K. Sketch – CMSK011

N. Sketch – CMSK014

NEW COMBINATION HARFORD ACADEMY & ELEMENTARY SCHOOL
1608 EVA MAR BOULEVARD, BEL AIR, MARYLAND

DATE	DESCRIPTION
01/23/26	ADDENDUM #2

PROTECTIVE COVER DETAIL @ CANTILEVER

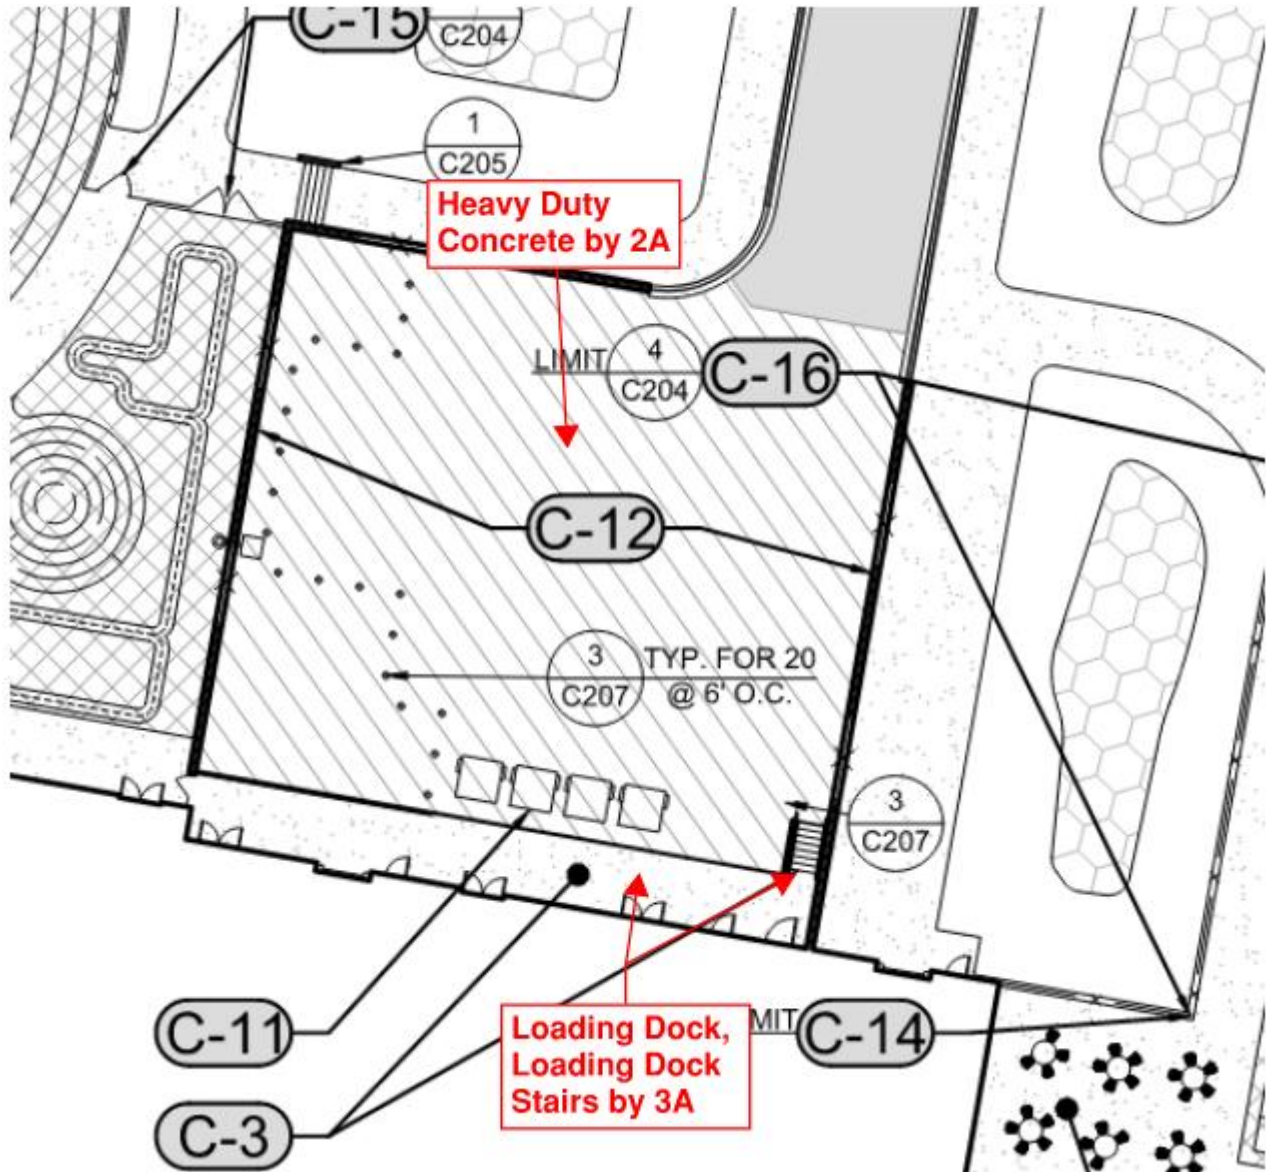
L. Sketch – CMSK012

REMOVE EXISTING BUILDING SLAB FOUNDATION AND ASSOCIATED BASE MATERIALS. EXISTING BUILDING DEMOLITION TO SLAB PERFORMED BY OTHERS (NIC).

2A Contractor shall include demolition and removal of existing Building.
